SPARTAN CHASSIS, INC.

RSB06-520-001A

RECALL SERVICE BULLETIN

SUBJECT: Current Distribution – Brake Light Circuit

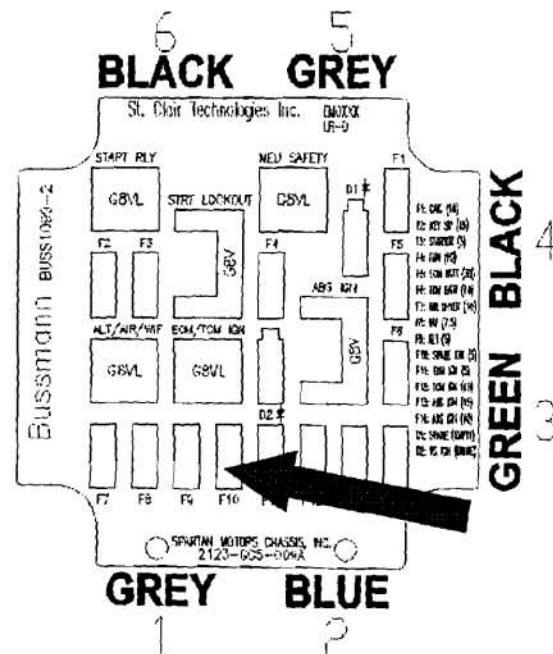
9. Contain the harness relays along with the excess harness and connectors with tie wraps or equivalent.

Note: Wires must be directed downward.

Note: Ensure any harnesses and hoses previously cut loose in step 2 are contained.

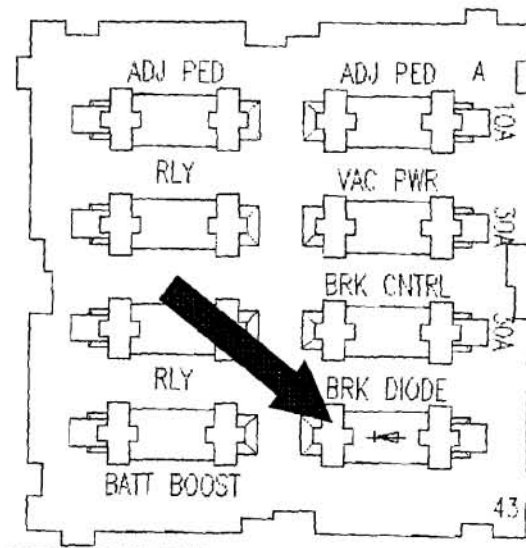
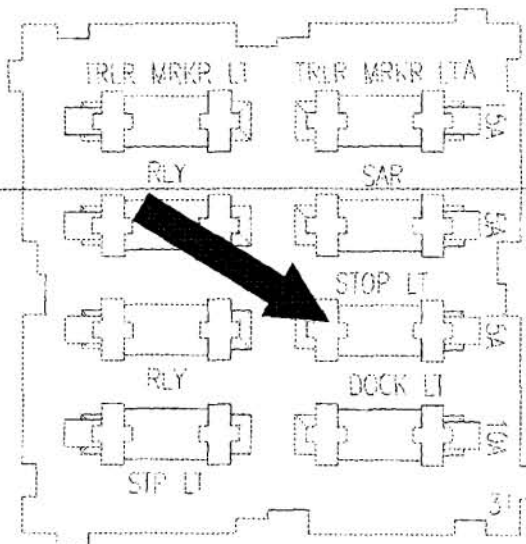
11. Verify and/or replace the STOP LT fuse located in the front PDC with a 15A fuse or 15A circuit breaker (determined by the kit being used).

12. REPLACE the BRK DIODE. This diode is located in approximately the center of the front PDC.

Note: Although the diode may still function and have no apparent defects, it may have internal damage.

Note: Diode must be keyed correctly as shown.

FIG. 6-1

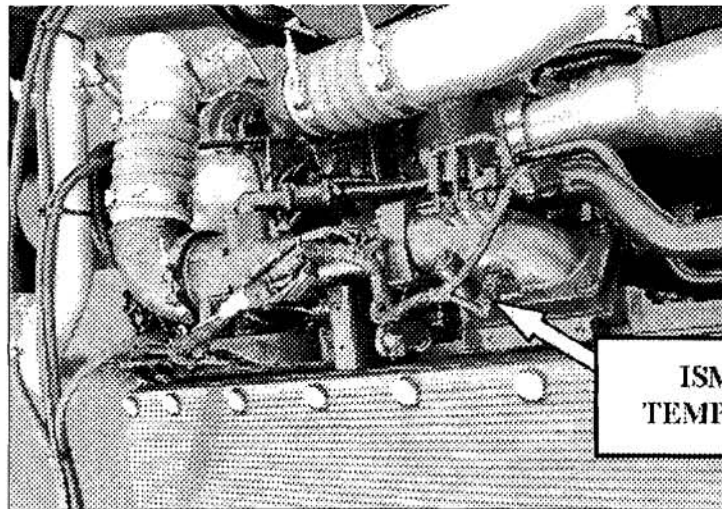
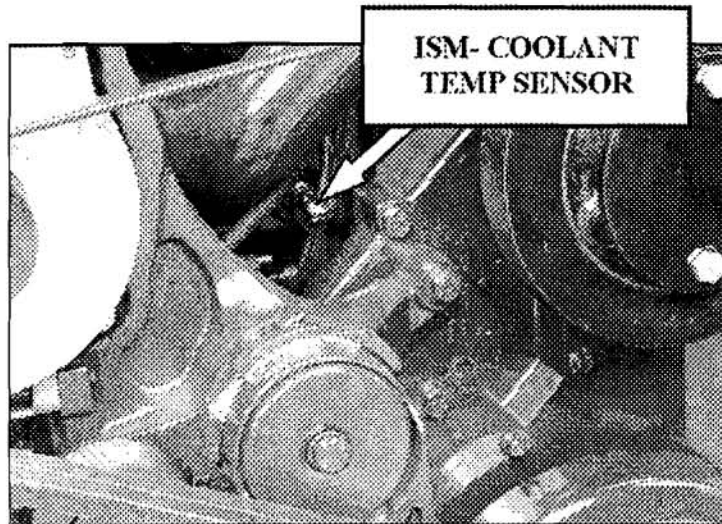
- e) Cooling fan operation for ISM and ISX engine by unplugging either the cooling temperature sensor or the CAC temperature sensor on the engine.

Refer to FIG. 6-1 for ISM temp sensor locations and FIG. 7-1 for ISX temp sensor locations. When either sensor is unplugged, the fan clutch automatically engages. When the sensor is plugged back in, the fan clutch disengages.
